工程指示 / 要求簡箋(E.I.)

工程指示編號：EI / 6407 / 23

工程編號： J - 858

工程名稱：將軍澳日出康城 11

FS-10-CAN

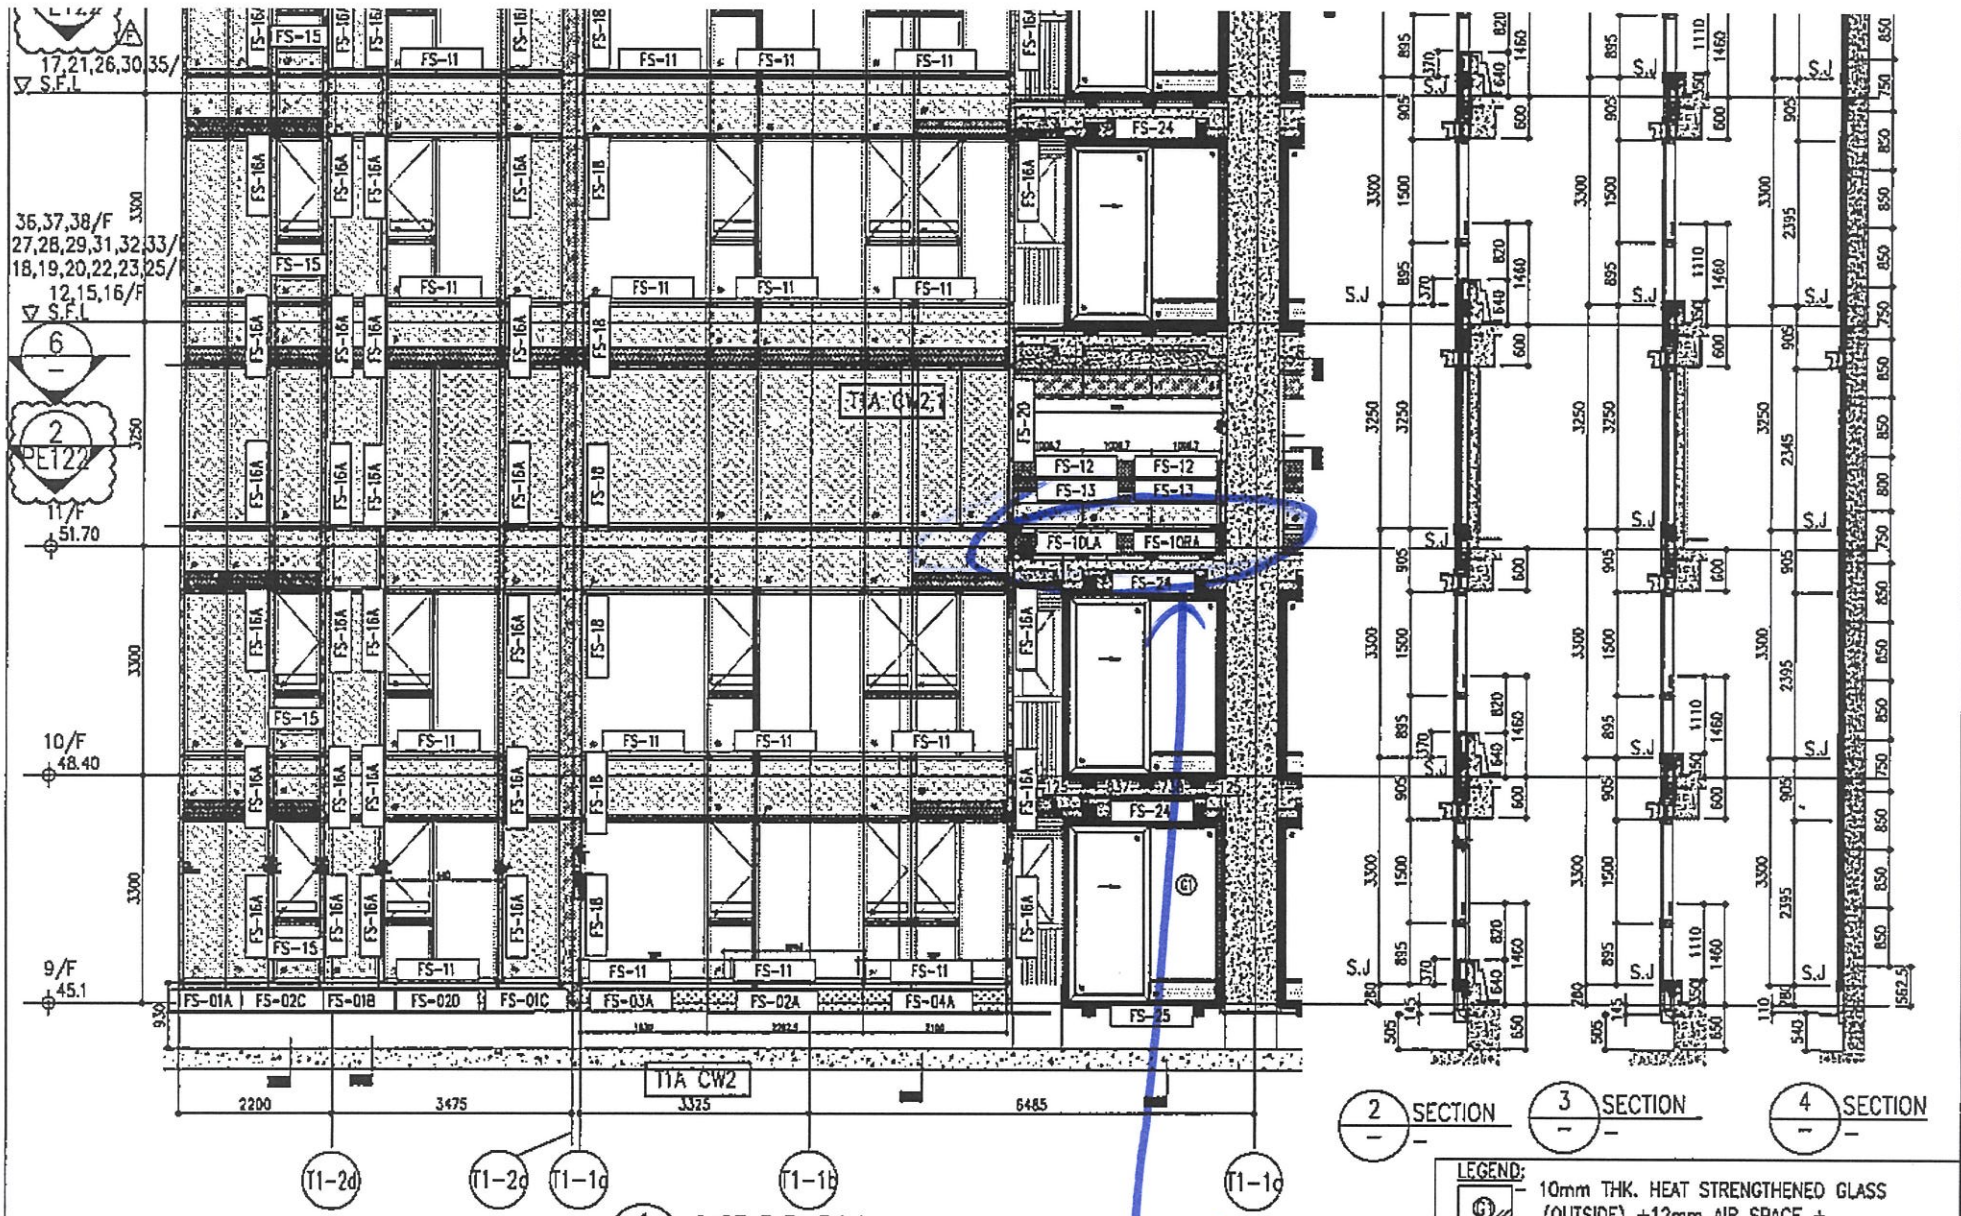
1.8 mm
~~1.8 mm~~

已拉直, 下与左右用.

14T	60T	54
T1	26	26	10
(已修整) T2	26	26	10
T3	26	26	10

高度 420 mm

与层与层对齐

先出6件在急

1 TYPICAL TRANSOM DETAIL CURTAIN WALL

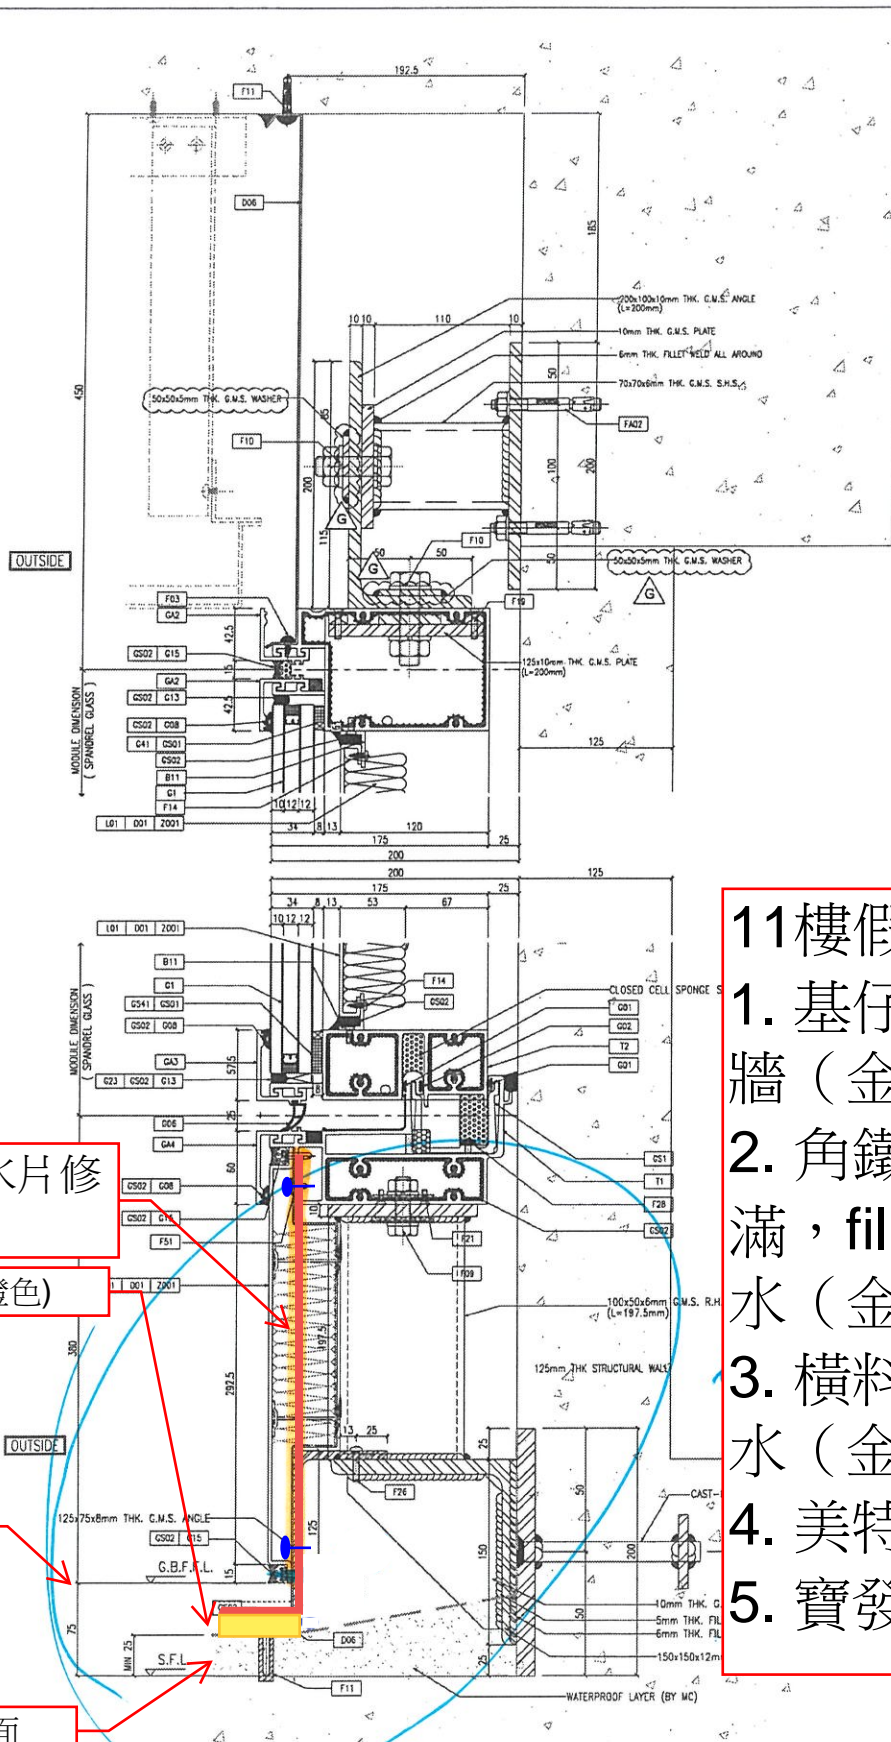
- 11樓假露台工序：
1. 基仔落至碰矮牆（金門）
 2. 角鐵至基仔之間填滿，fill平角鐵免積水（金門）
 3. 橫料底做斜面免積水（金門）
 4. 美特防水片
 5. 寶發防水片

4. Midi 防水片修在鐵面
4. 壓膠（螢光橙色）

1. 基仔

2&3. 防水和做斜面

美特铝质有限公司 MIDI Aluminium Fabricator Ltd.				工程號	J858	類別		物料號	-			
				地盘	康城11期	制圖	W. E. X	2022-08-11	圖號	FS-10R		
修改	-	-	-	採用工廠	✓	地盤	圖紙名稱	铝防水板加工图	復核	-	數量	-
日期	-	-	-	材料颜色	CHROMATE	/	材料	1.5mm THK. 铝板	批准	-	單件重量	- (KG)

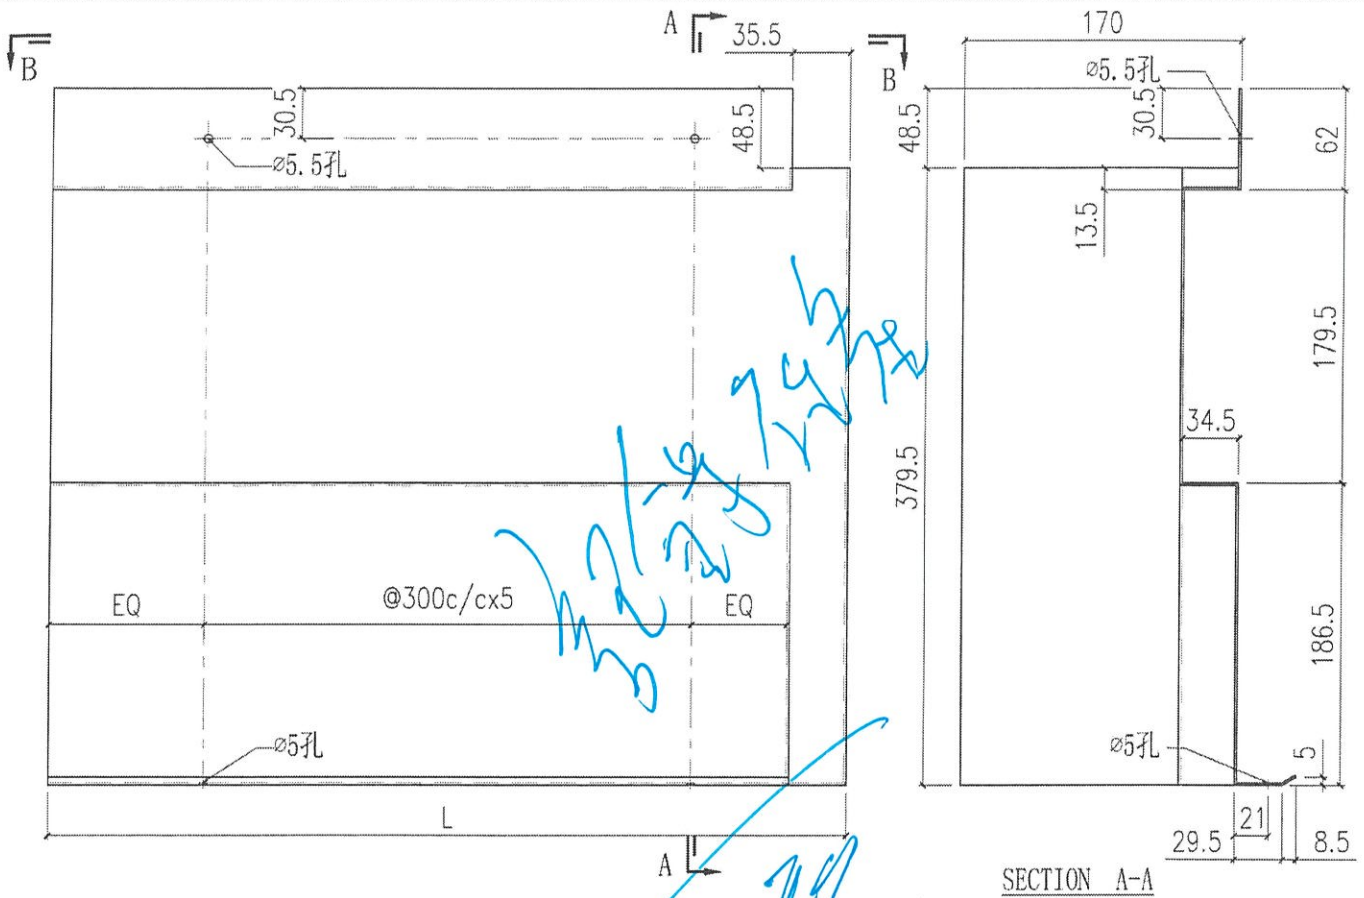
按現場判頭需要，隔火層露台乾底下的防水片，(預直)：

請按加工圖生產防水片送地盆用，

FS-10-CAN 1.5mm 厚，所有防水片需鉻化，共 200 件

急送 6 件到地盤

分座分層打扎
